PHILADELPHIA ELECTRIC COMPANY

Subject: Limerick Generating Station, Unit 2
Power Ascension Test Program

Enclosure: LGS-2 Power Ascension Test Program Changes

STARTUP TEST 3 - FUEL LOADING
TEST SIMPLIFICATION - ELIMINATE FUEL LOADING CHAMBERS

Figure 1 - Proposed Fuel Loading Sequence

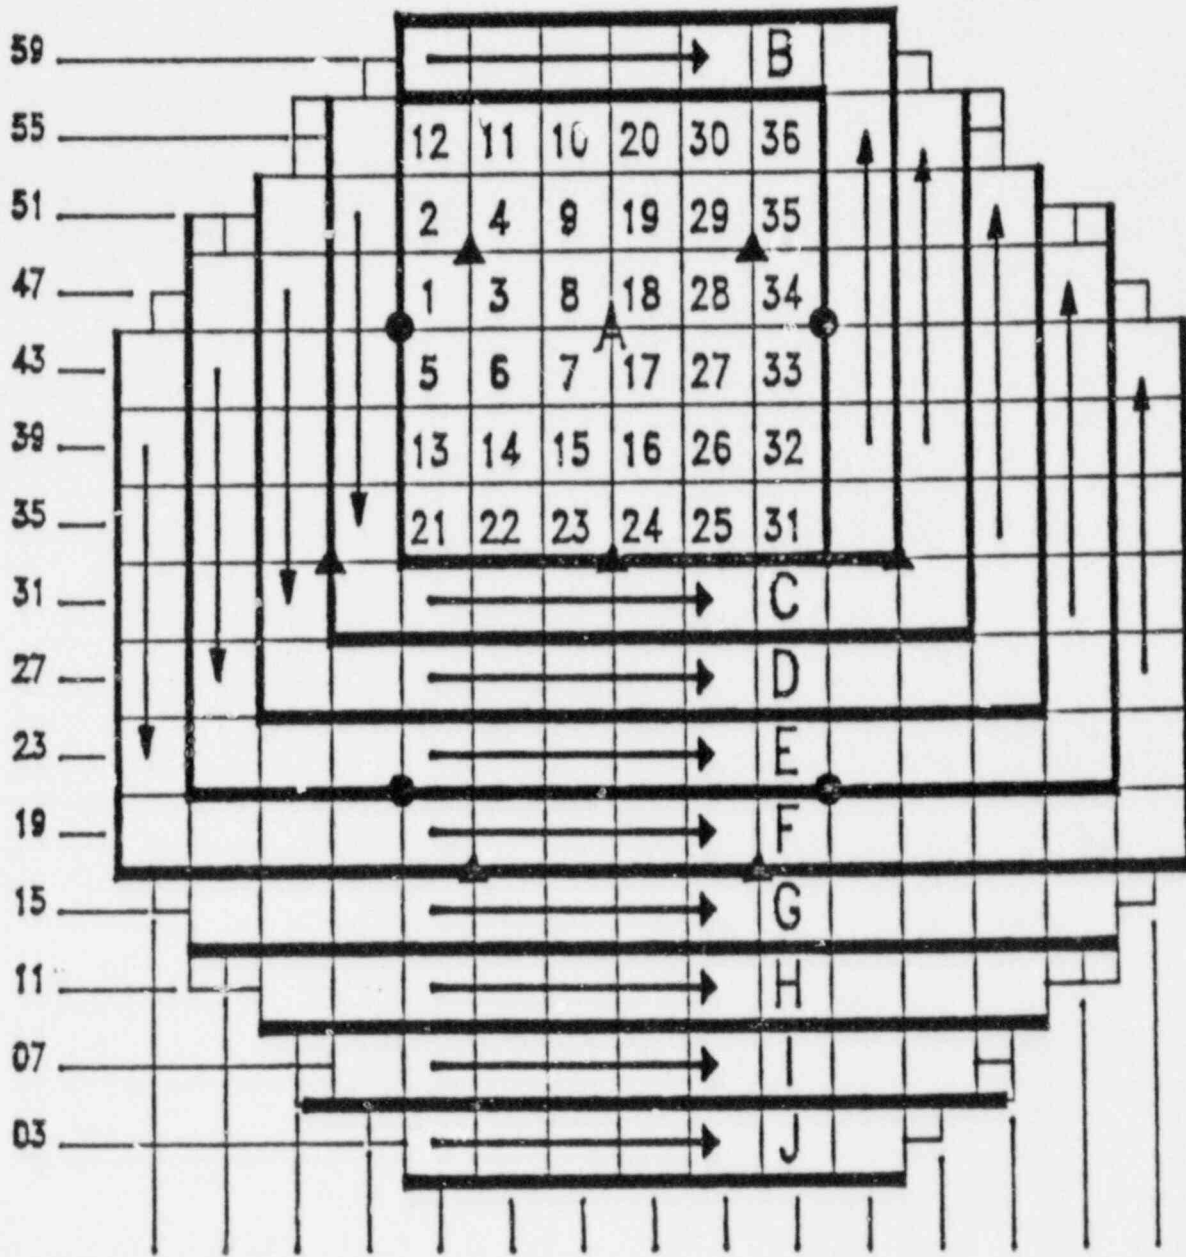
For the proposed fuel loading procedure, the fuel will be initially loaded between a source at its alternate location and the closest SRM. Figure 1 shows the proposed fuel loading sequence. Because of the fixed location of the SRM's and the distance from the sources, the SRM count rate will initially be less than 0.7 counts per second (cps), the LGS-

After the initial 16 bundles are loaded and an SRM is on scale, the fuel loading will continue in a spiral fashion as shown in Figure 1. Since only one SRM will initially be on scale, a portable source will be used to periodically demonstrate operability of the SRM's located in areas with no fuel. One of the SRM's will be required to maintain continuous visual indication in the control room until other SRM's are on scale. Use of a portable source to demonstrate operability of the remaining SRM's has previously been approved by the NRC for other plants (References 5, 7, 8, 9, and 10). The portable source is widely used in the nuclear industry as a bugging source for detector calibration and is an easy device to operate with no complex or unsafe maneuvers required.

When 144 fuel bundles have been loaded (Step 36 in Figure 1), two SRM's will be surrounded by fuel and indicating greater than 0.7 cps. At this time, a partial core shutdown margin test will be performed as required by Regulatory Guide 1.68. The partial core configuration (fuel bundle types) for this off-center loading is almost identical to the partial core configuration resulting from a standard center spiral loading. Core physics calculations for the off-center partial SDM test will be performed for the proposed fuel loading sequence. After the partial core SDM test, the remaining fuel will be loaded based on the sequence shown in Figure 1 until the core is fully loaded. During this portion of the fuel loading, at least two SRM's will be operable, with at least one providing continuous visual indication in the control room. SRM's not surrounded by fuel will be periodically checked for operability using the portable source. Once the core is fully loaded, the full core SDM test will be performed using the standard procedures. Attachment 1 provides a summary of the major fuel loading steps.

Figure A-1 - Proposed Fuel Loading Sequence

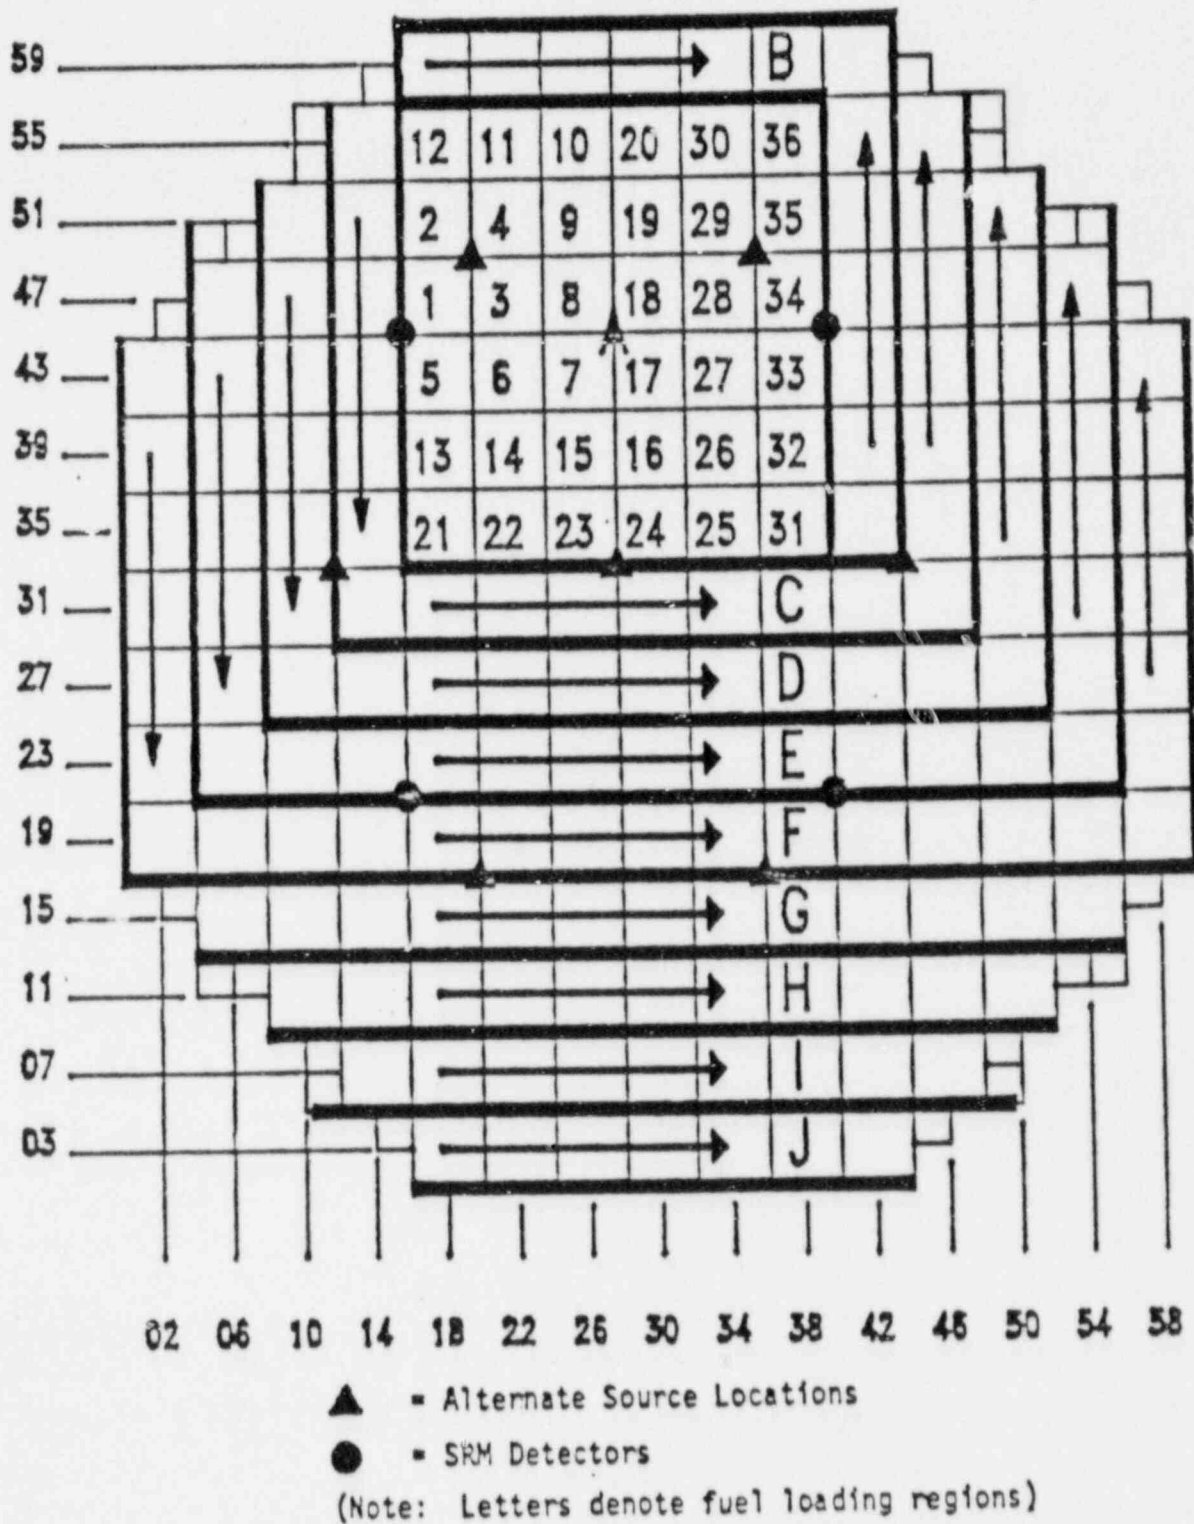
- a. Begin fuel loading following the steps shown in Figure A-1. (Off-center loading).
- b. Fuel loading begins at cell location 18,47 and continues until the first 16 bundles have been loaded (Steps 1-4, Figure A-1).

- d. Continue fuel loading according to Figure A-1 until Region A is completely loaded (144 bundles). During the process of fuel loading, SRM(s) count rate should be recorded. This is used to generate 1/M plots. Perform control rod functional tests and subcritical tests when the minimum SRM count rate is achieved on at least one SRM channel.

- e. Perform the partial core shutdown margin test after 144 bundles are loaded (Region A, Figure A-1). Core physics calculations will be performed to support this test.

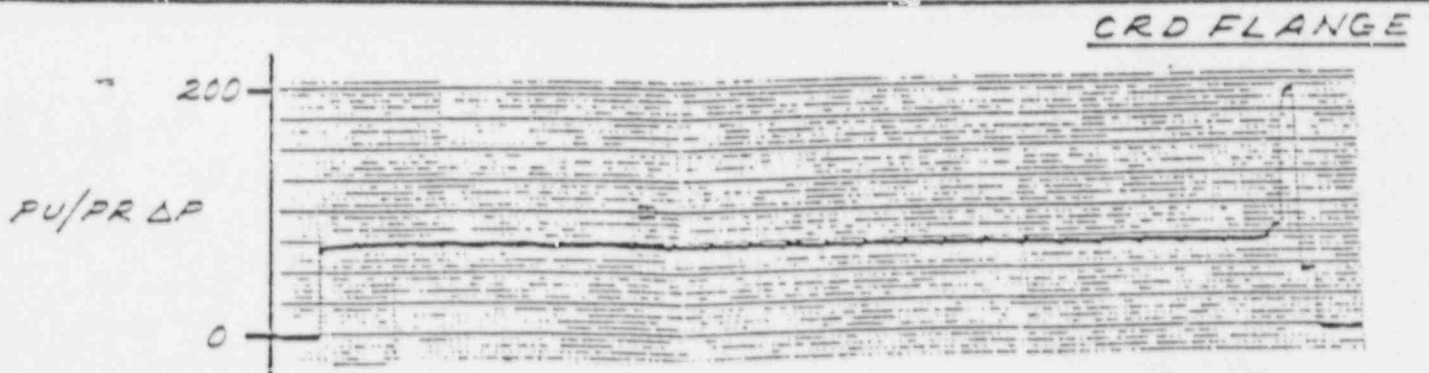
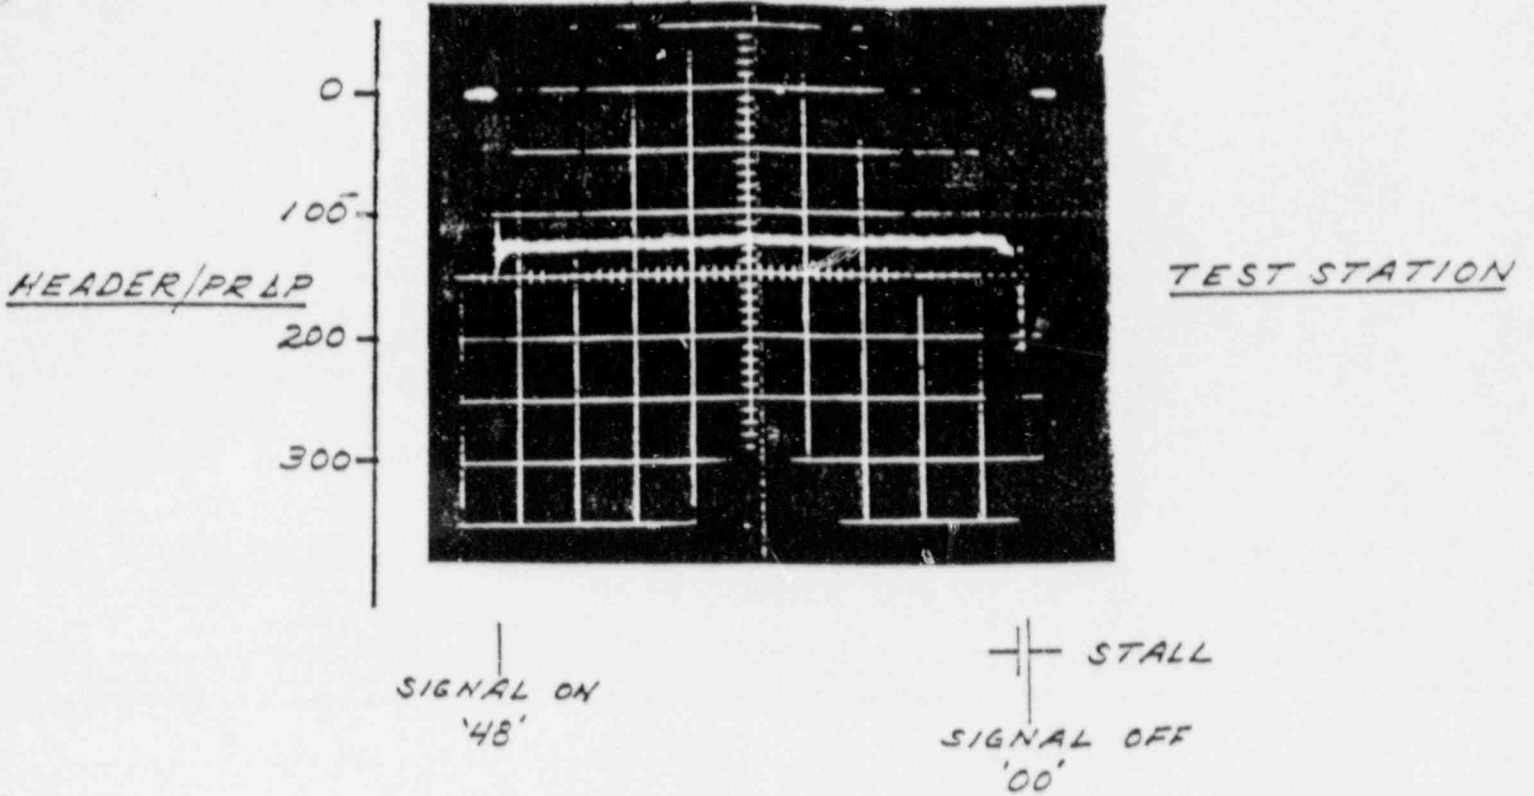
Therefore, it is unnecessary to friction test all the CRDs at hot conditions and it is recommended that only four CRDs be hot friction tested to demonstrate that there is no thermal expansion problem. The four CRDs chosen should be the same as those for which scram timing is to be repeated during subsequent test conditions.

Additionally, the differential pressure between the drive water header downstream of the CRD Friction Testing Station and reactor pressure is an acceptable substitute for the differential pressure between the insert and withdraw lines for performance of CRD friction testing and either method may be used. Figure 4, taken from NEDE-31511, shows a comparison of pressure differentials between header pressure and reactor pressure (PR) for the test station and pressure differential between pressure under piston (PU) and reactor pressure (PR) for pressures sensed across the CRD flange.

Figure 7

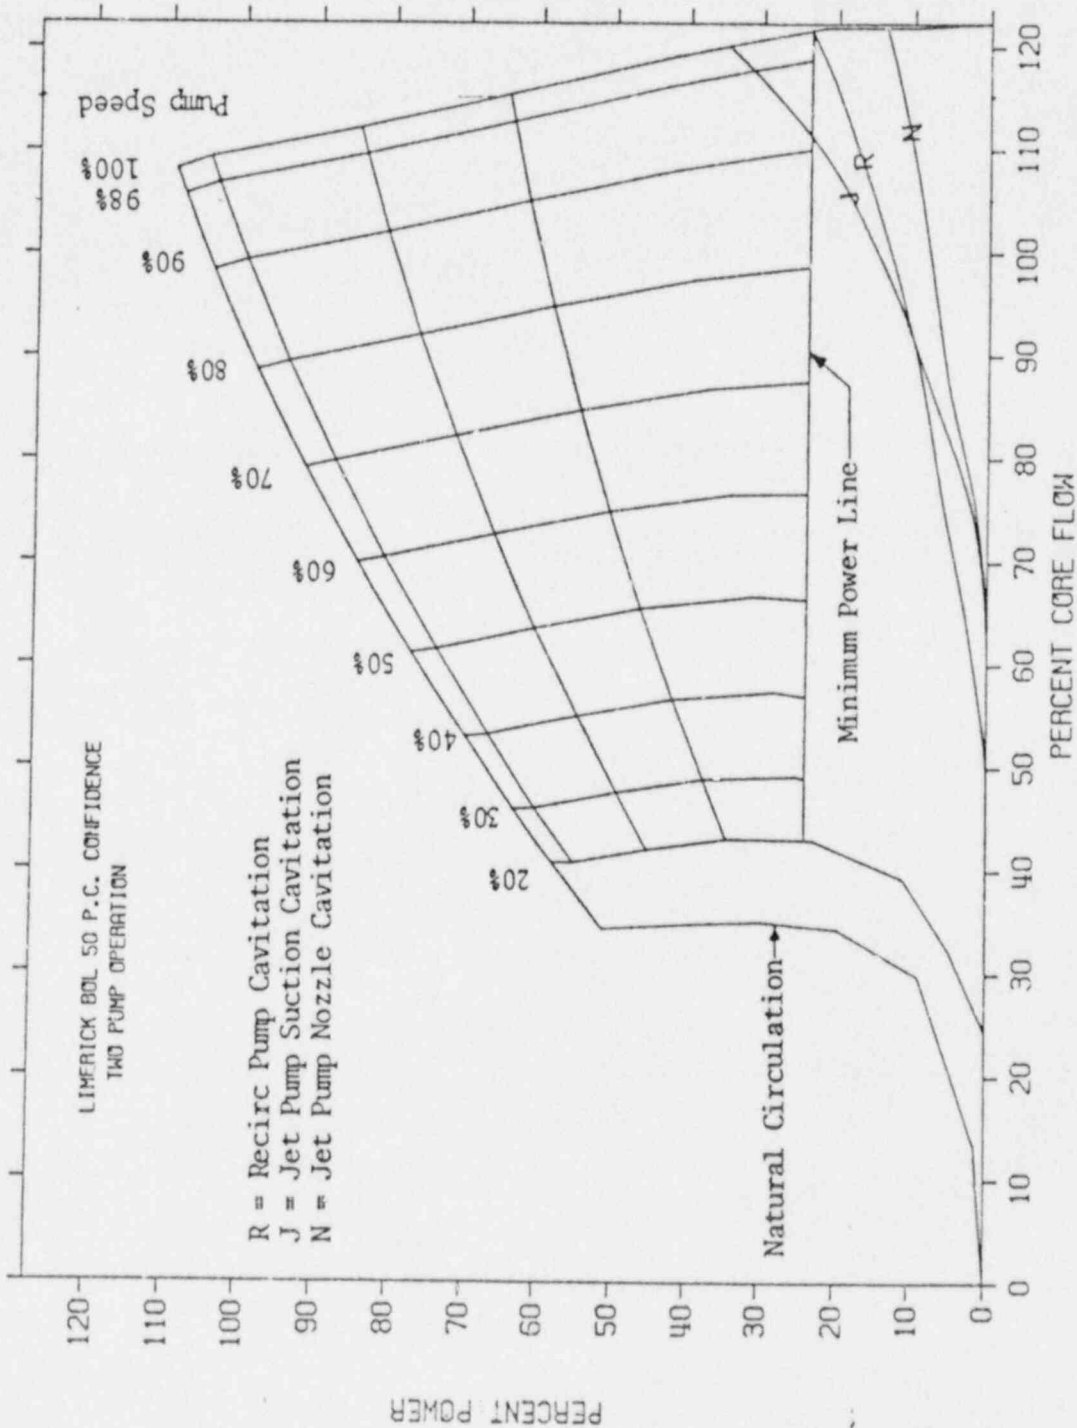
The predicted cavitation curve for the jet pumps is based on empirical data determined from the Moss Landing test program. The recirculation pump cavitation curve is based on the pump vendor supplied data. Based on this information the interlock is set at 20% feedwater flow. At normal operation, rated core flow, there is about a 10% power margin between the interlock setpoint and predicted cavitation. The margin increases as flow is reduced as shown on the attached figure.

Cavitation interlock setpoints are designed to allow maximum operation in the power/flow map but are conservatively set to assure that no recirculation system cavitation occurs. Tests at LGS Unit 1 and previous BWR startups have demonstrated that cavitation interlock setpoints have been conservative, and therefore since no cavitation has been observed prior to reaching the interlock setpoints, the deletion of this test is justified. This proposed testing deletion will not adversely affect any safety related systems or safe operation of the plant. Therefore, Startup Test 30E, Recirculation System Cavitation, can be deleted as stated above.
